Lower Thames Crossing

5.4.1.1 Final Agreed Statement of Common Ground between (1) National Highways and (2) the Environment Agency (Clean version)

DATE: December 2023
DEADLINE: 9A

This is the Final Agreed Draft Statement of Common Ground between (1) National Highways (the Applicant) and (2) the Environment Agency.

Plate 1: Proposed location of HRA and ecology mitigation

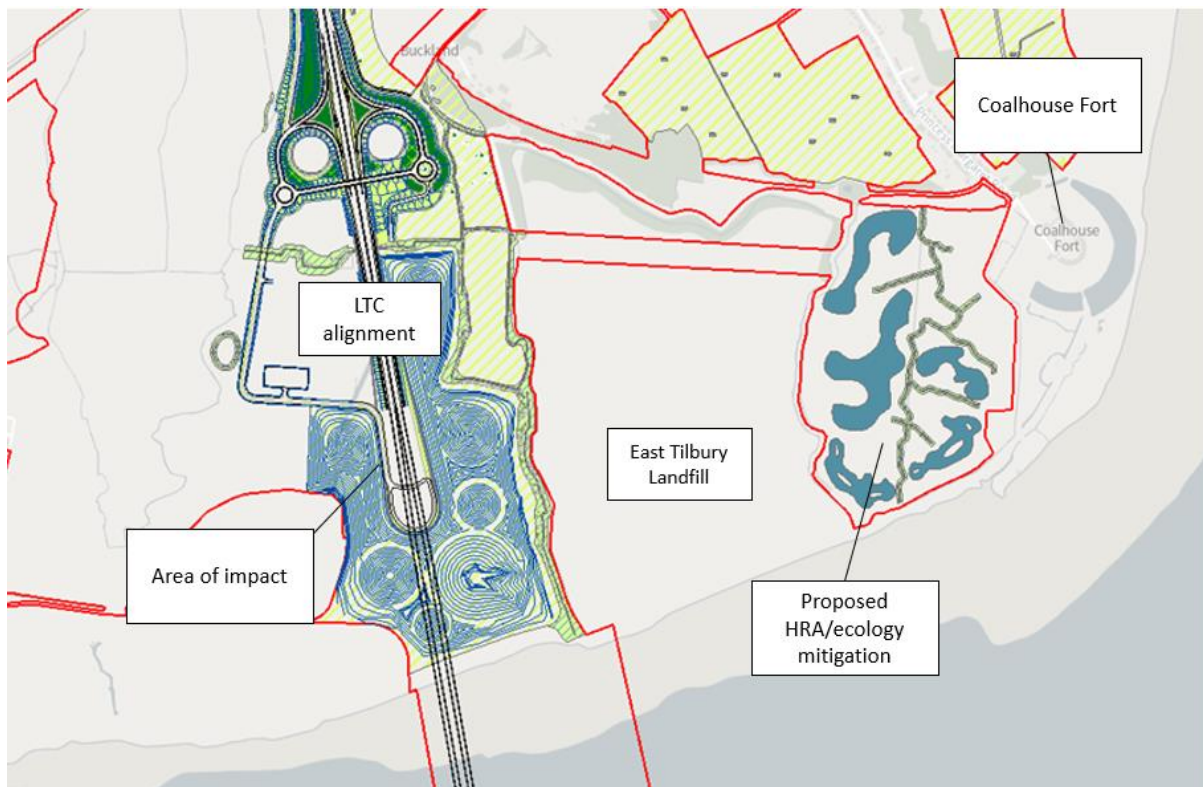
- The HRA and EIA require evidence that proposed mitigation is feasible. Natural England have advised that feasibility of the mitigation will need to be presented before they would be able to agree the sufficiency of the mitigation in the SoCG, which is a DCO acceptance risk and DCO consenting risk.

Plate 2: Proposed amendments to the DCO Order Limits to provide the 50mx20-35m working space for the construction of the sluice structure. Approximate amendments to Order Limits to incorporate flood defence also highlighted.

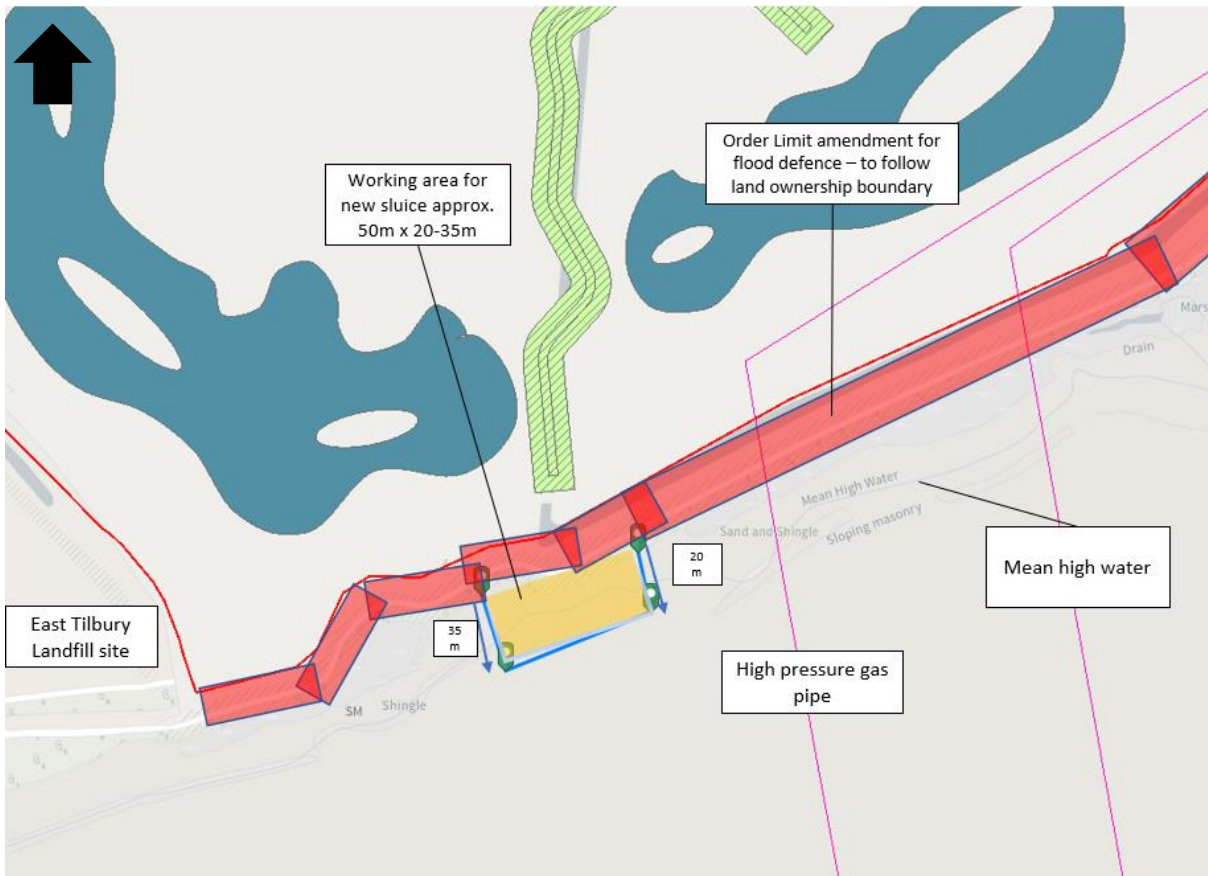
It was proposed to amend the Order Limits to incorporate the existing flood defence that is currently owned by the landowner, Mr Mott. This change was proposed irrespective of the requirement of a structure and is shown as the red area in Plate 2. Given the new structure would be limited to the footprint of the flood defence, this change would also incorporate the new structure.

Figure 1: Impact of increased defence levels on breach start and end times at Mardyke Sluice breach (based on future level for Option 1.4 in 2127)

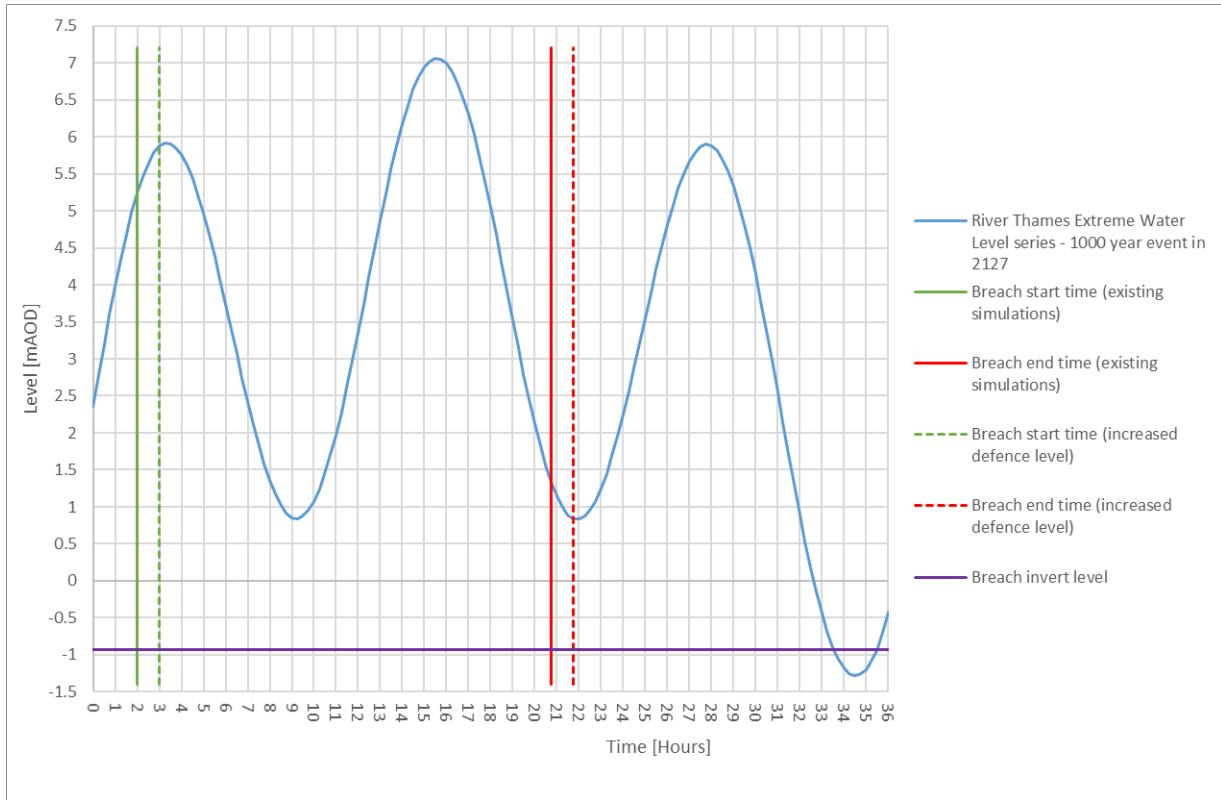
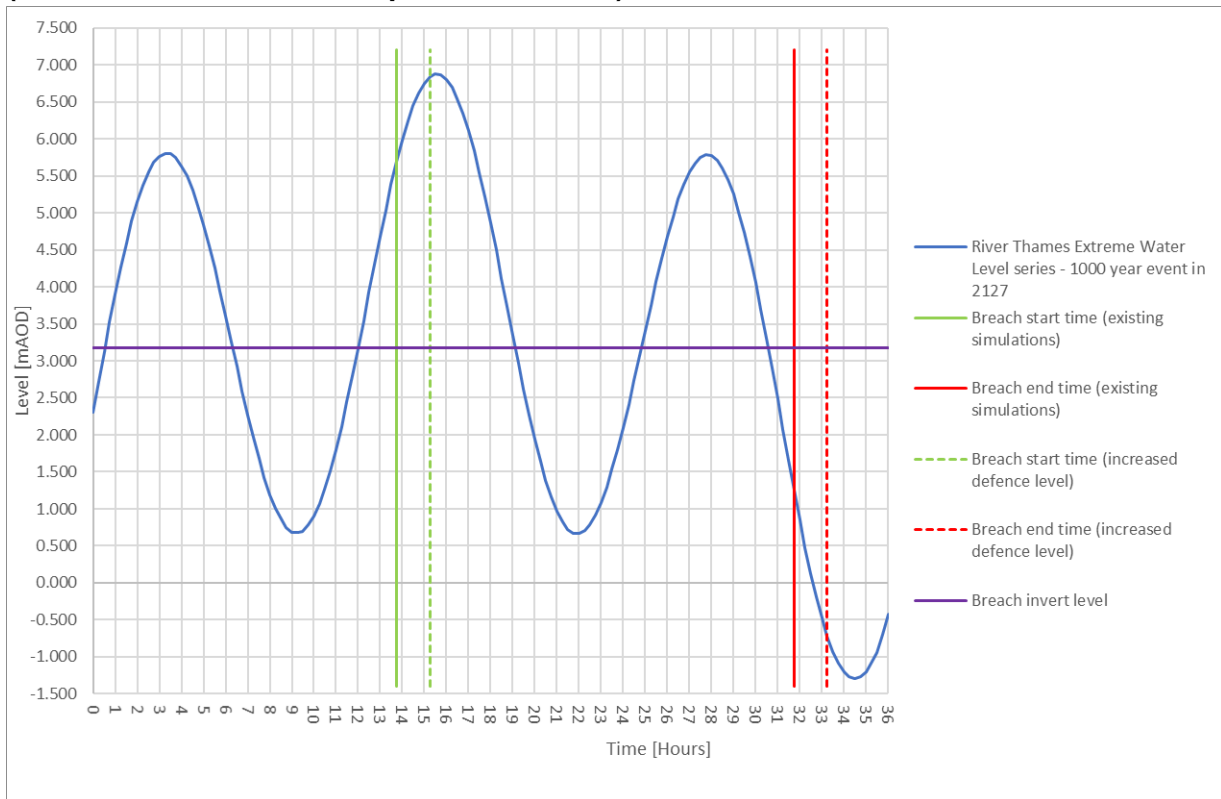
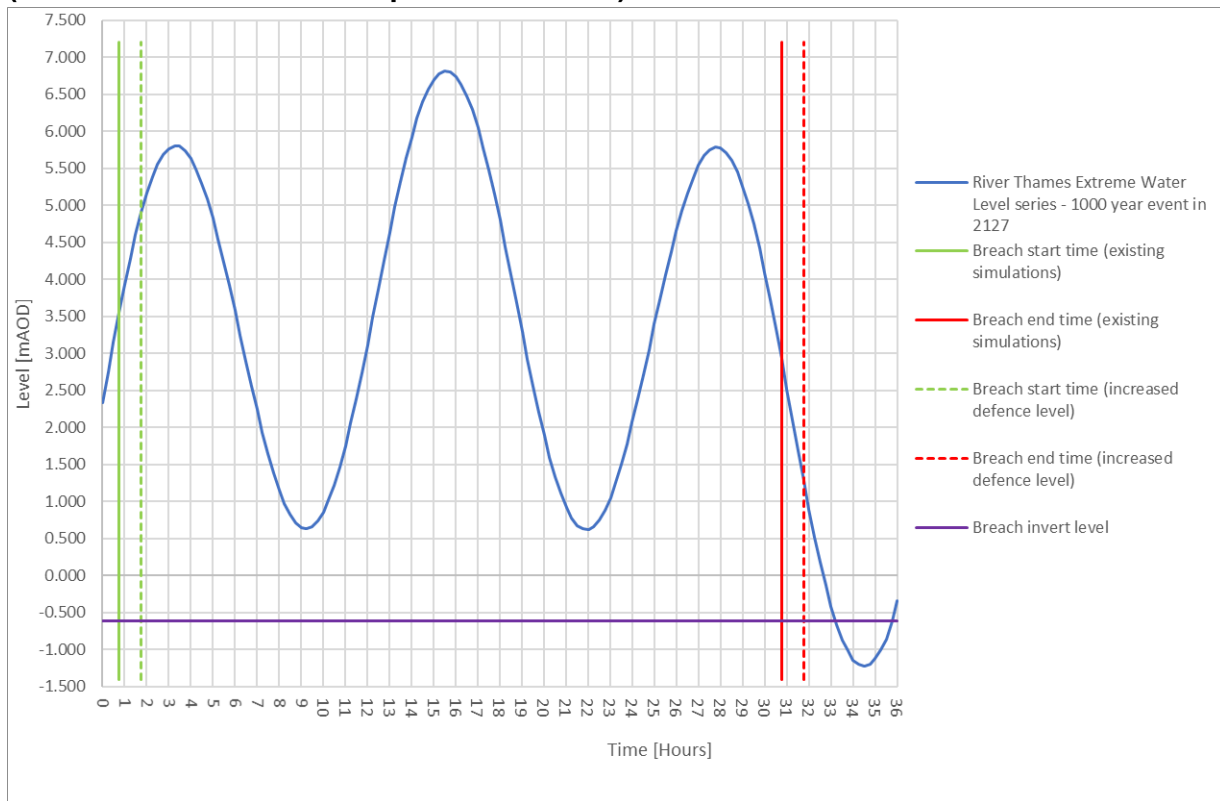
2.2.5 Figures 1 to 3 show that for all LTC FRA breach locations, applying higher flood defence levels results in a delay in the start and end times of simulated breaches. An inspection of Figures 1 to 3 indicates that the reduction in initial breach flows resulting from increased defence levels (due to a delayed start) would exceed the gain in breach flows at the end of the simulated breach event, as River Thames flood levels are higher at the start of simulated breach events than at the end of the events (and for TIL005 there would be no gain in breach flows at the end of the simulated breach event, as River Thames levels would be below the TIL005 breach invert level at the end of the simulated beach). There would therefore be an overall reduction in simulated breach flood volume as a result of increasing flood defence levels.

2.2.6 The LTC FRA breach simulation results show the nearest parts of the LTC Project within TIL005 and TIL006 breach event flood extents are approximately 2km and 0.8km respectively from the breach locations, with simulated peak velocities significantly lower than at the breach locations. The influence of an increase in flood defence levels on breach impacts at the LTC Project would therefore be dominated by total breach volume (i.e. breach flood extent and level).
